**PRELIMINARY SAFETY AND ENVIRONMENTAL
INFORMATION DOCUMENT**

VOLUME V

**GAS-COOLED
FAST REACTORS**

**NONPROLIFERATION ALTERNATIVE SYSTEMS
ASSESSMENT PROGRAM**

Figure B-1. GCFR six-loop PCRV. Loop arrangement with top exhaust steam generator.

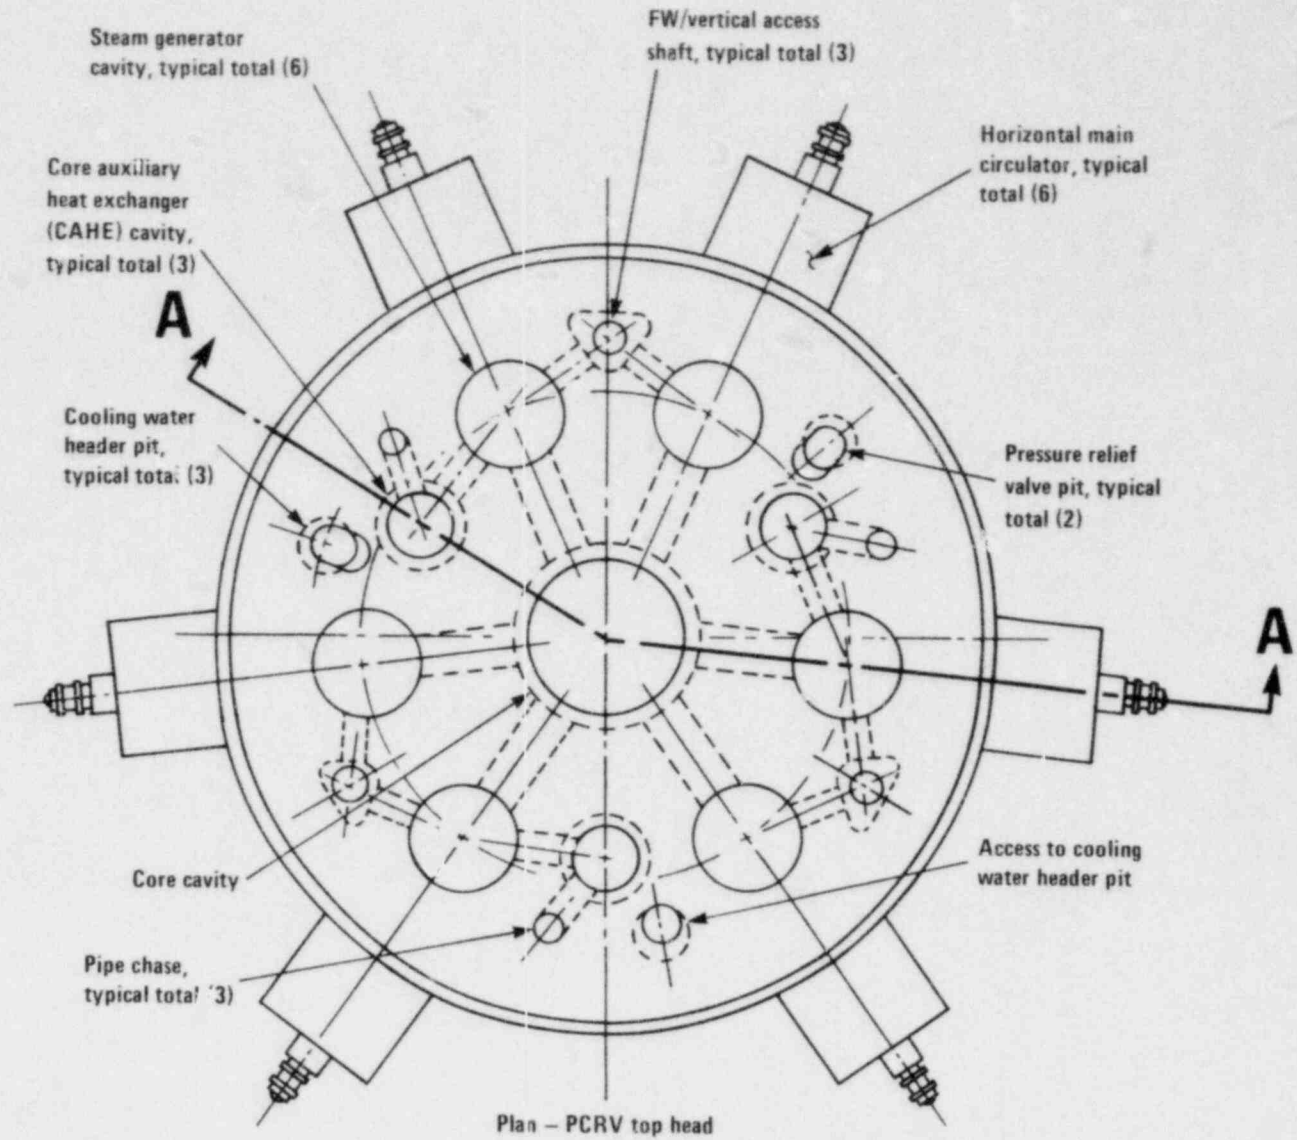
In the event that the upflow core-cooling design is adopted for the gas-cooled fast-breeder reactor (GCFR), it will be necessary for the U.S. Department of Energy (DOE) to re-describe the principal design features of the GCFR and provide an assessment of its safety characteristics in the prevention and mitigation of postulated accidents. This documentation should address all 13 of the safety considerations given on page 2-21 (page 2-20 of this volume) of the preliminary safety and environmental information document (PSEID), provide discussion of any additional safety considerations that the DOE considers necessary and appropriate, and address all of the comments and questions contained herein in the context of the upflow design. We foresee that the upflow design would not adversely affect our general conclusion given in the 1974 Preapplication Safety Evaluation Report and that some of our conditions and reservations regarding the adequacy of the present emergency core-cooling provisions might be positively addressed. Criteria related to the adequacy of thermal margins and fuel damage in the case of natural convection cooling would have to be developed in connection with the assessment of the adequacy of the use of natural convection for emergency core cooling.

The PCRV configuration for a 1,200-MWe plant and the arrangement of the components in the six primary and three auxiliary coolant loops are shown in Figures B-1 and B-2. The central cavity contains the reactor core and shielding and is sealed by a concrete closure. The coolant flow for a primary loop (Figure B-2) is upward through the core into the core outlet plenum, then through the hot-gas duct to the steam generator cavity. From here the coolant flows downward across the steam generator tube bundles to the main helium circulator that pumps the helium to the core inlet plenum at the bottom of the central cavity. The helium circulators are located in horizontal penetrations in the bottom head of the PCRV.
